SUBJECT : Replacing EPROM on Visibility Processor Board and Installing Visibility Crossarm Cable Guides

EQUIPMENT AFFECTED : Automated Surface Observing System (ASOS)

CERTIFICATION STATEMENT : This modification is authorized by Engineering Change Proposals E92SM05F054 and E93SM05F086. It was tested by the Engineering Division at Silver Spring, MD.

VISIBILITY PROCESSOR BOARD
 P/N 32194-1
 FIGURE 2

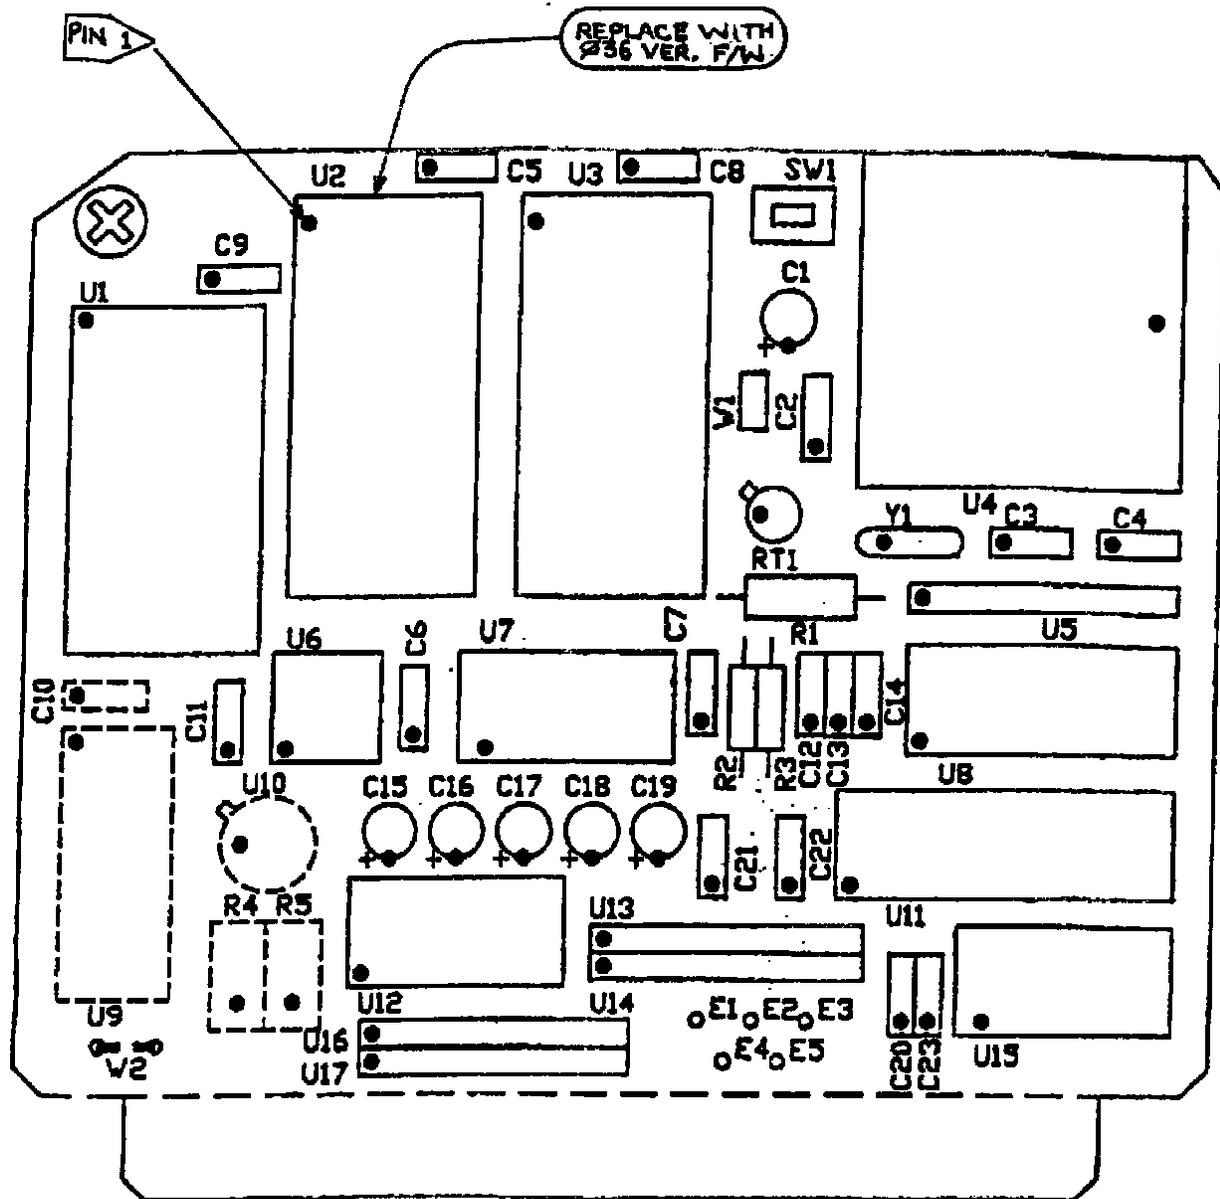
The EPROM on the visibility processor board changes from version 034 to 036. This change is accomplished by replacing the EPROM with the new version EPROM. The old EPROM must be returned to NRC with this completed form so reprogramming and reissuance can occur. Refer to the attached instructions to accomplish the modification.

Table 1 provides the procedure to remove and install the visibility firmware by removing and replacing EPROM U2. Figure 2 illustrates the location of the EPROM U2. After completion of the firmware upgrade procedure, the EPROM removed from the visibility processor board should be packaged in appropriate electrostatic discharge protective material for return to NRC.

4. Carefully remove processor board by pulling it free from backplane connector XA1.
5. Using the drawing supplied, locate microcircuit U2. If version number is 034 or lower, remove U2.

6. Install supplied version 036 microcircuit, using care to match the index notch with the notch in the chip socket. Press firmly into socket.
7. Install processor board into backplane connector XA1.
